May 31, 2016

Re: FirstLight Hydro Generating Company, Turners Falls Hydroelectric Project (FERC No. 1889) and Northfield Mountain Pumped Storage Project (FERC No. 2485).
Response to Stakeholder Requests for Study Modifications and/or New Studies Based on the Study Report and Meeting Summary

FirstLight GDF SUEZ

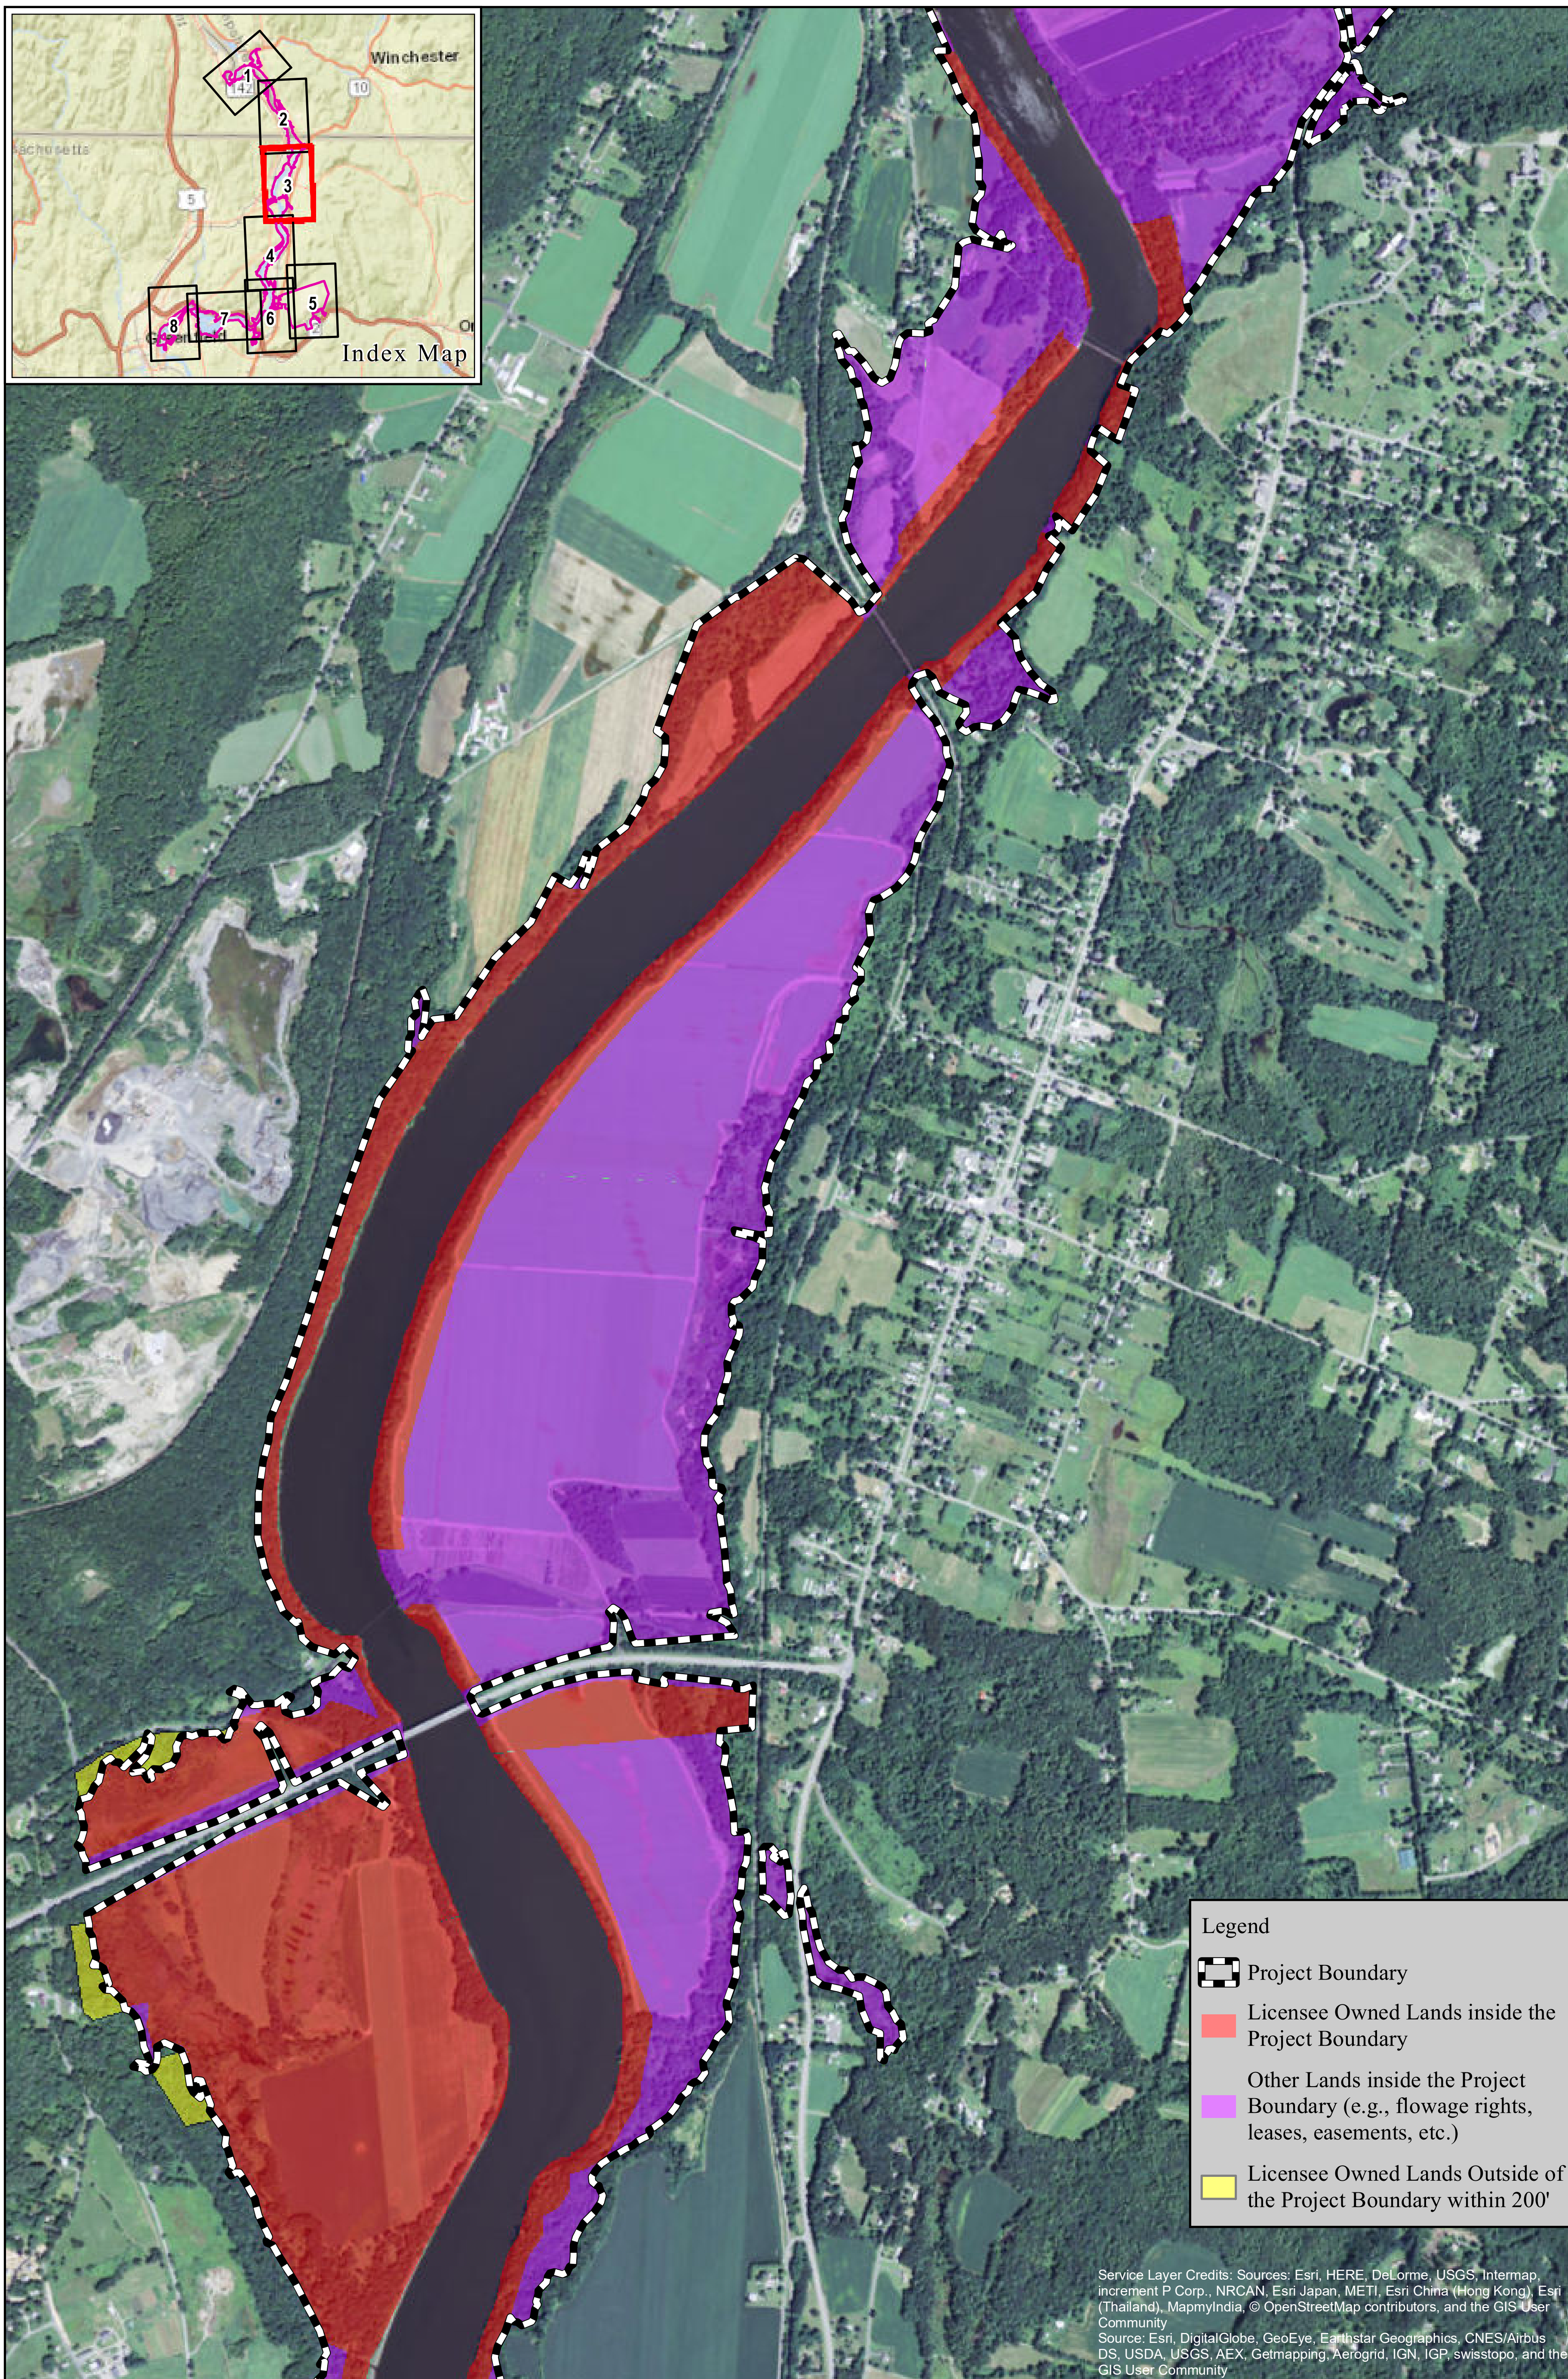
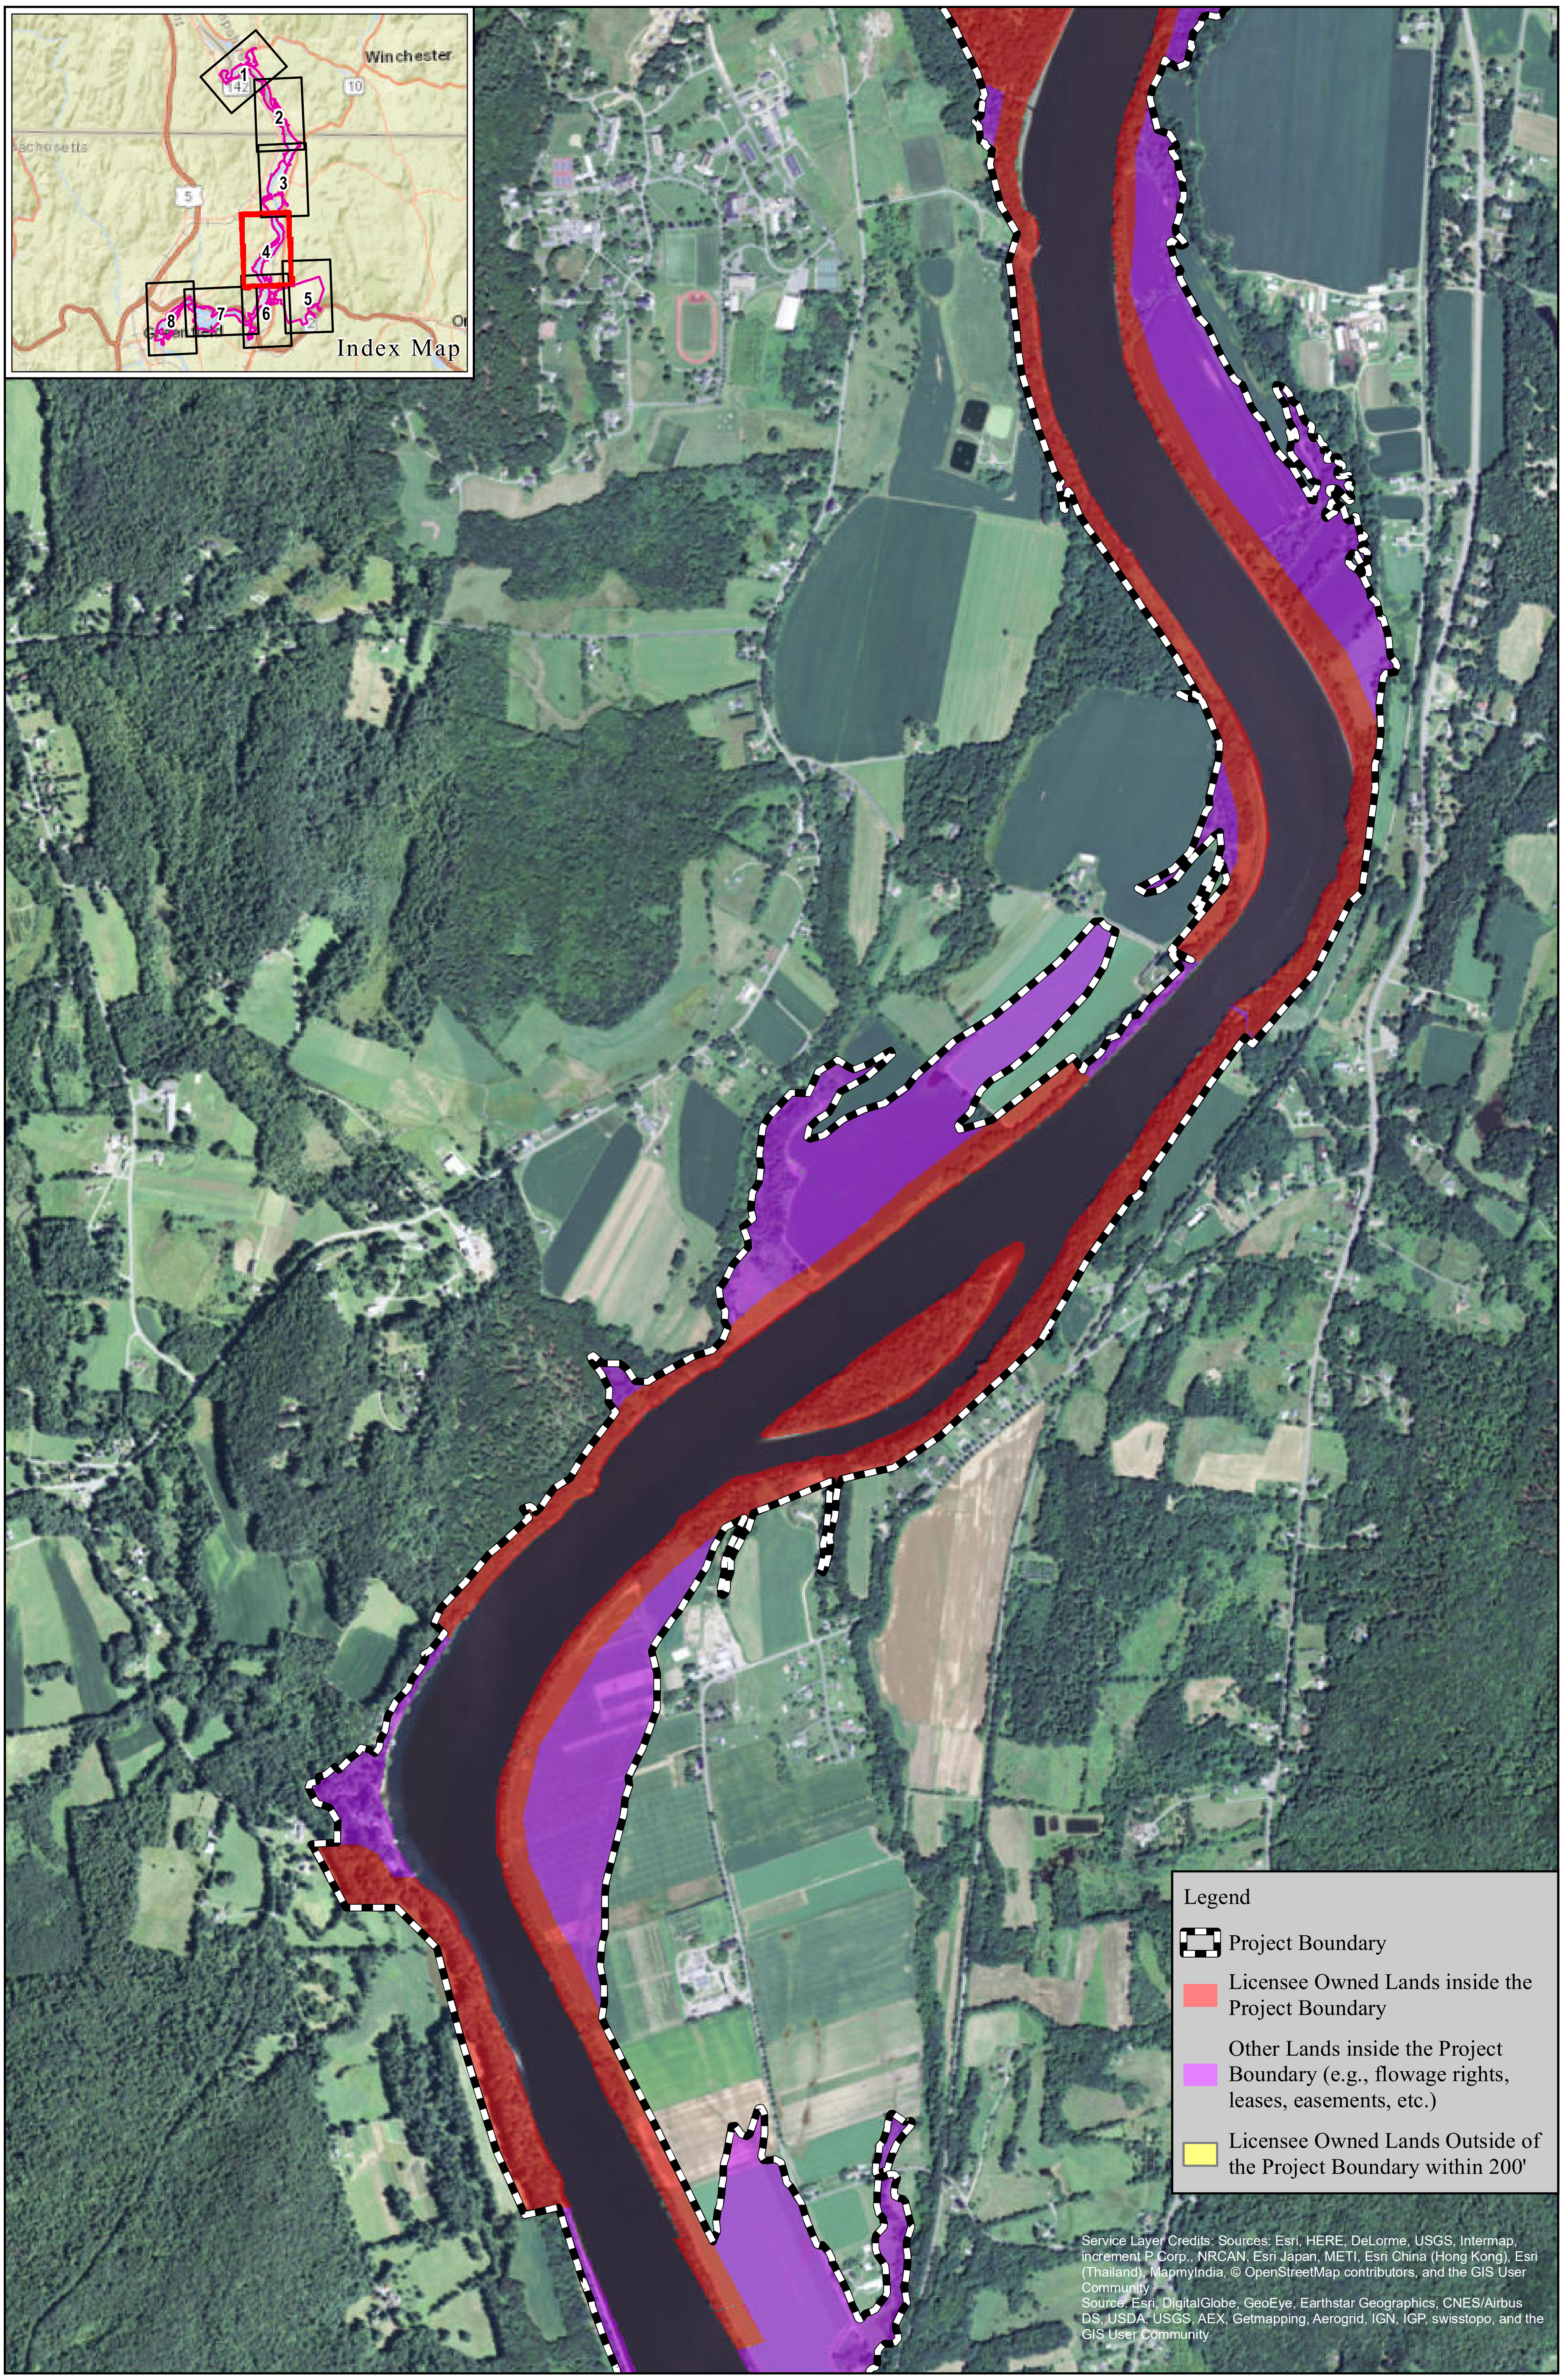
Commenter	Comment	Responses
CRWC-1	The report does not identify ownership and other controls such as FirstLight's flowage rights within the Project boundaries. FirstLight does not own all of the lands within the project boundaries. FirstLight ownership of lands within 200 feet of the Project boundaries is identified in Figure 4.4-1, but nothing indicates ownership within the boundaries. CRWC requests that FirstLight provide information on land it has ownership or any other control over, and the land use associated with those lands, in an addendum to Study 3.6.5.	FL has updated the maps that comprise Figure 4.4-1 in the 3.6.5 study report to show FL land ownership within the project boundary. See Study 3.6.5 Attachment A, Figure 4.4-1. The lands owned by FL shown are fee-ownership. The figures also show other lands within the Project boundary (e.g., flowage rights, easements, leases, etc.). The land uses associated with all lands within the Project boundary are provided in the 3.6.5 study report. An addendum to the 3.6.5 study report is not necessary.
